Millstone Nuclear Power Station, Unit No. 3
Revised Response to SER Confirmatory
Item 58

Revised Responses
To
SER Confirmatory Item 58

SER Confirmatory Item 58 - Emergency Diesel Engine Fuel Oil Storage and Transfer System

TABLE 8.3-1 (5 OF 6)
EMERGENCY GENERATOR LOADING:
EMERGENCY LOAD SHEDDING

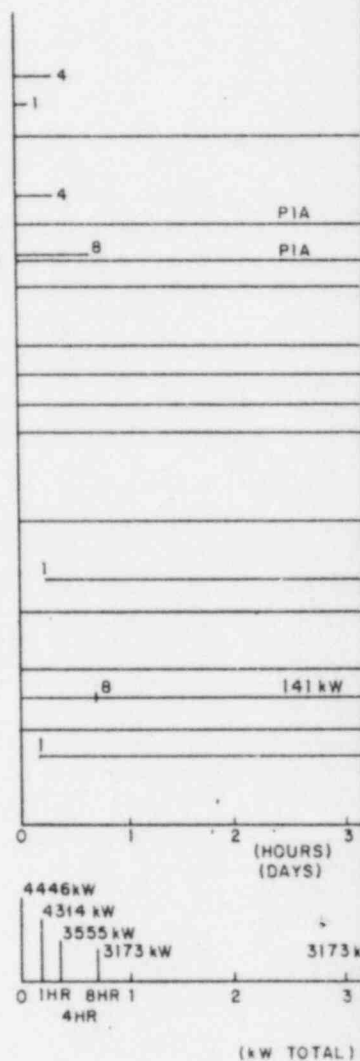
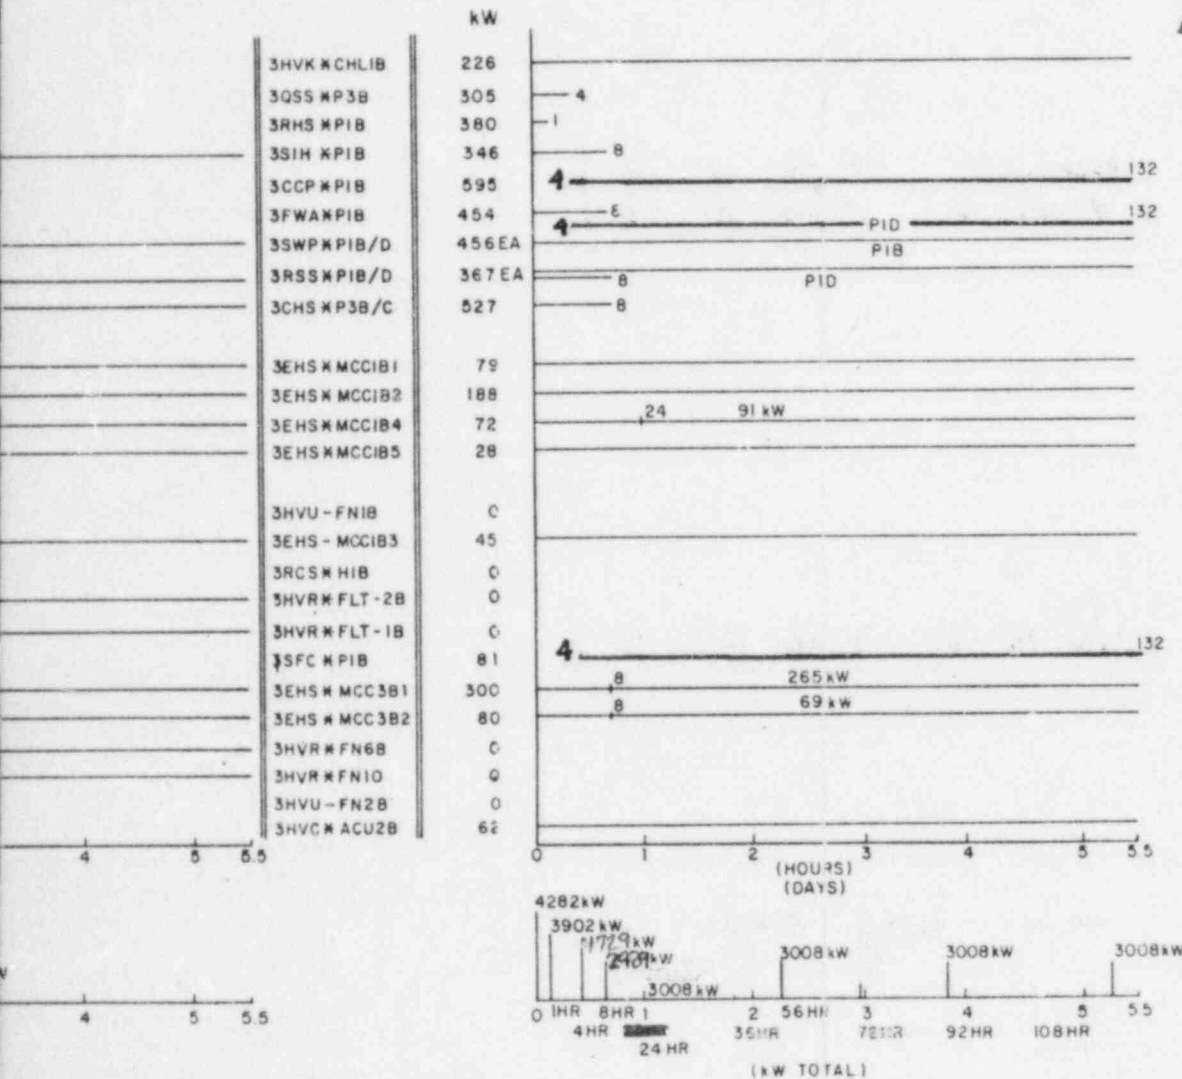
The emergency diesel generator load-shedding/fuel capacity analysis indicates that 8 hours into the worst case fuel consumption accident, which is a DBA coincident with a LOP, the loads may be reduced to approximately 60% of rated capacity on Train A and to approximately 35% on Train B. The load on Train A remains constant where the load on Train B would increase to approximately 60% at 4 hours. As requested by the Staff, please find attached the Emergency Diesel Generator Load-Shedding Tables which provide a listing of the loads to be shed or placed onto the bus and at what point in the transient this is to be accomplished.

TABLE 8.3-1 (6 OF 6)
EMERGENCY GENERATOR LOADING:
EMERGENCY LOAD SHEDDING

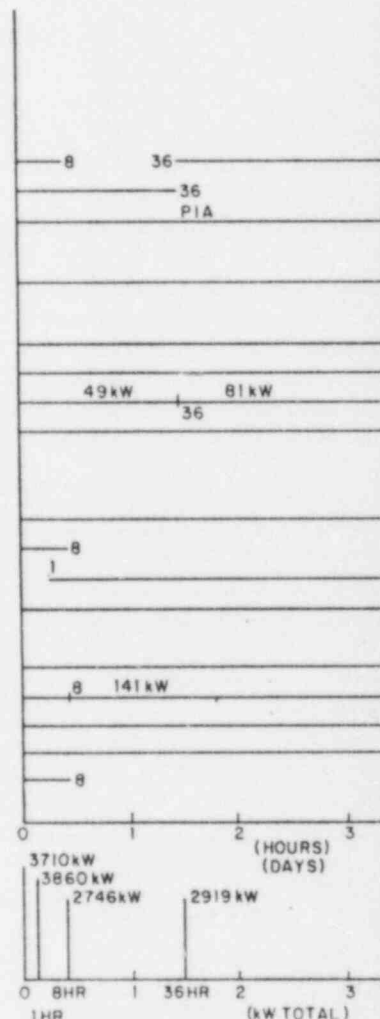
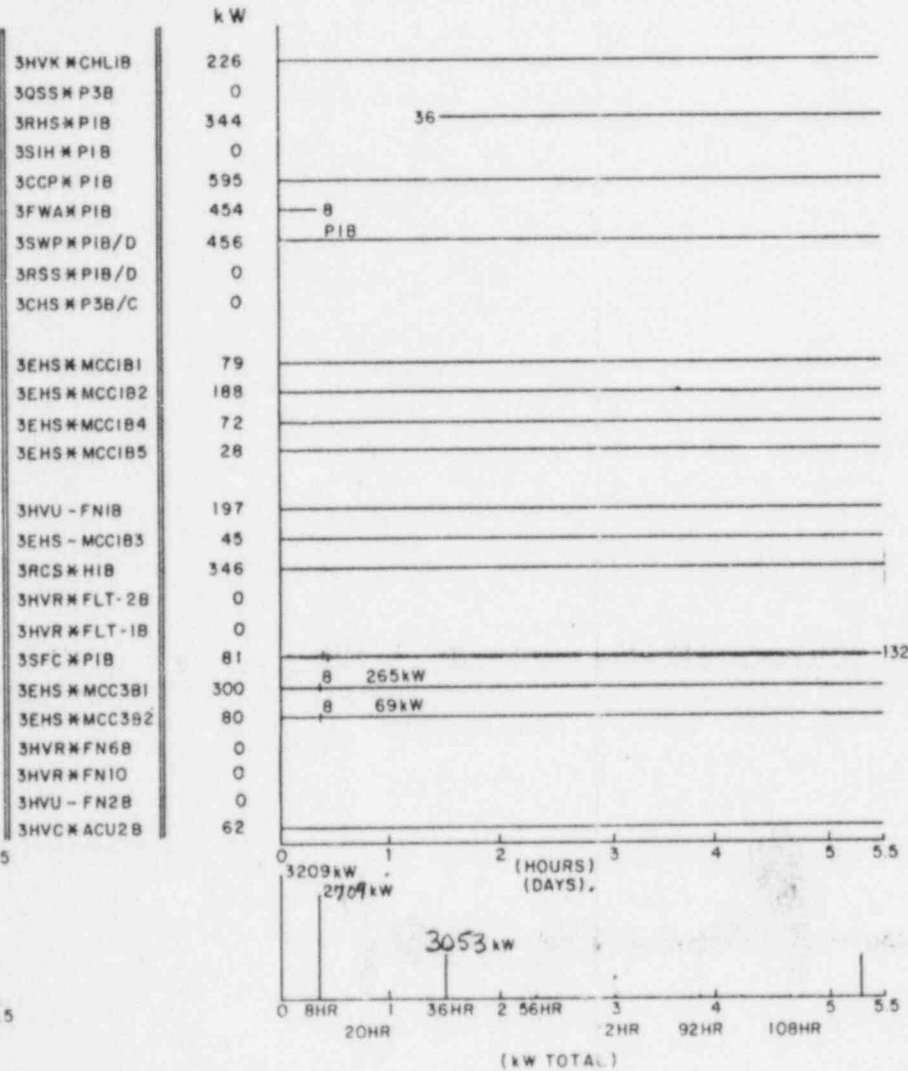
For the diesel generator load shedding scenario, an elapsed time of approximately 5 1/2 hours is required before 140°F is reached. This is based on the same fuel loading configuration in the spent fuel pool as described in FSAR Section 9.1.3.3, but assumes 25 days following reactor shutdown. The 25 day criteria is a conservative time for return to power following a shutdown for refueling. With the fuel pool loading configuration as discussed, the heat load is 1.48×10^7 BTU/hr. The initial pool temperature, under these conditions and assuming a maximum CCP temperature, would be 118.9°F. The rate of temperature rise in the fuel pool, following a loss of cooling, would be 3.95°F/hr. At this rate, the fuel pool temperature would reach 140°F after 5.34 hrs. Once 140°F has been reached a reactor plant component cooling water and spent fuel pool cooling pump will be started. As can be seen in revised Table 8.3-1 (Sheets 5 and 6), the spent fuel pool cooling pump and the reactor plant component cooling water pump could be reinitiated at a conservative delay of 4 hours and would have a negligible effect on the ability to meet a diesel generator fuel oil supply for a minimum period of 5 - 1/2 days.
